Technical Service Bulletin No. 13

THIS BULLETIN REPLACES BULLETIN NO. 3 AND NO. 7 Pot FP Plus

Reference no: Pot FP Plus

Picture 1: Old type of potentiometers.

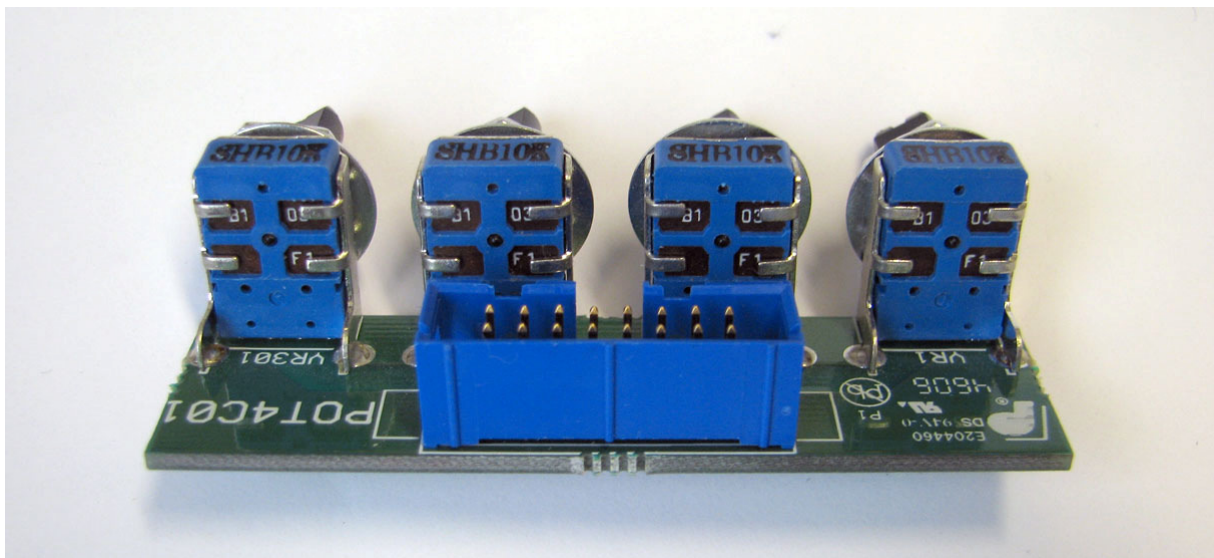
When doing service on a FP+ Series amplifier the potentiometers shall be exchanged if a POT-board with the old type of potentiometers is mounted. See picture below on how to identify the old type of potentiometer.

Old potentiometers (see picture 1 below) have plastic axis (black) and the new potentiometer have a steel axis. Both POT-board and UI-board needs to be exchanged since the new POT-board does not fit with the old UI-board.

UI12Lx203 and POT2B needs to be changed to UI12Lx205 and POT2B04 to get the new potentiometers to fit.

UI12Lx403 and POT4C needs to be changed to UI12Lx405 and POT4C03 to get the new potentiometers to fit.

Picture 2: The VR10KLIN31_TOK potentiometer.

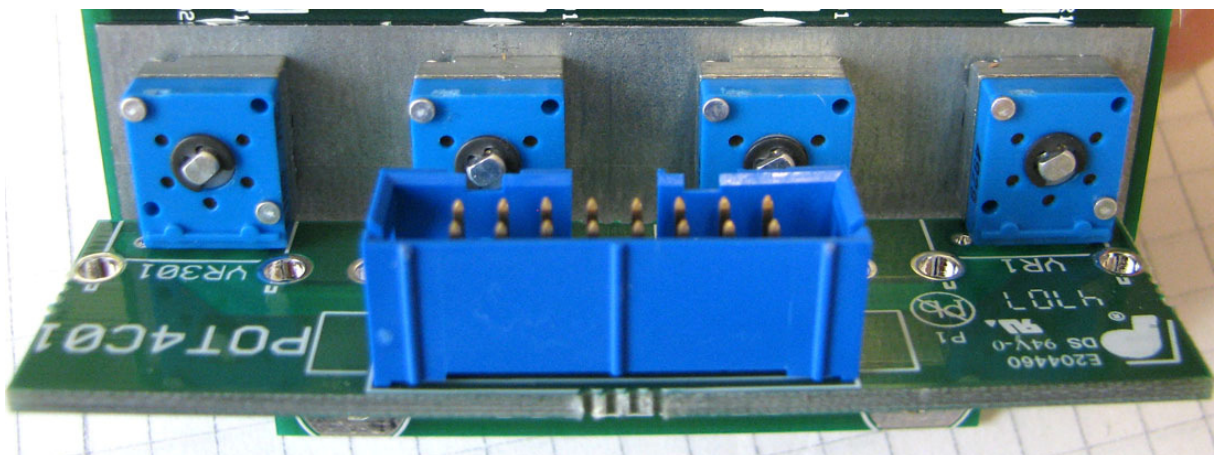
If the potentiometer VR10KLIN31_TOK (see picture 2 below) is mounted those does not need to be replaced, only potentiometers with plastic axis needs to be replaced. Difference between VR10KLIN31_TOK and VR10KLIN31HSBF is the supports on the sides.

Picture 3: The VR10KLIN31HSBF potentiometer.

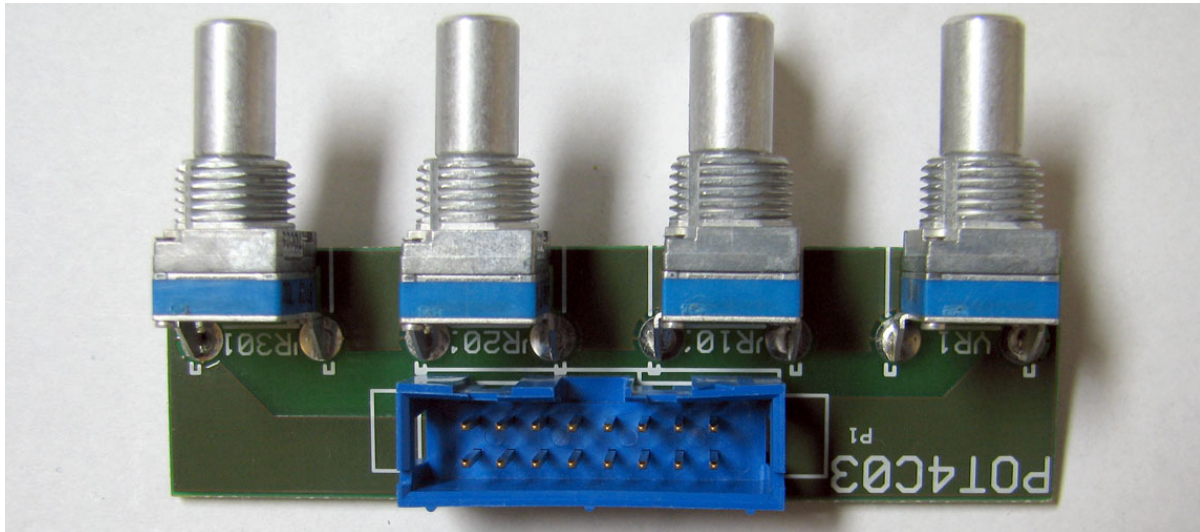
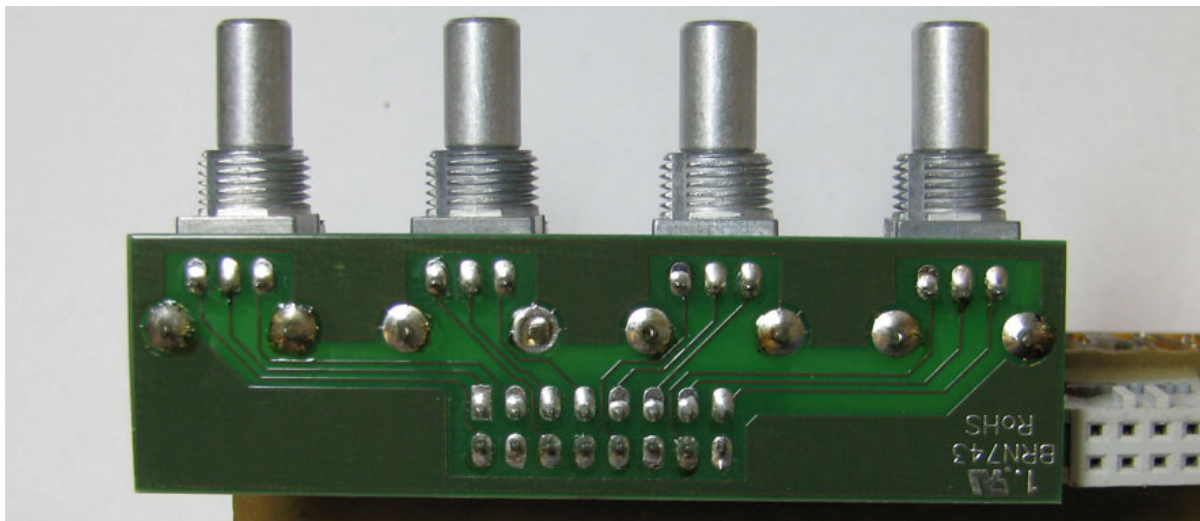
Distortion or dead channel due to bad potentiometers. Potentiometer VR10KLIN31HSBF replaces potentiometer VR10KLIN21H since the 21-step potentiometer has bad quality.
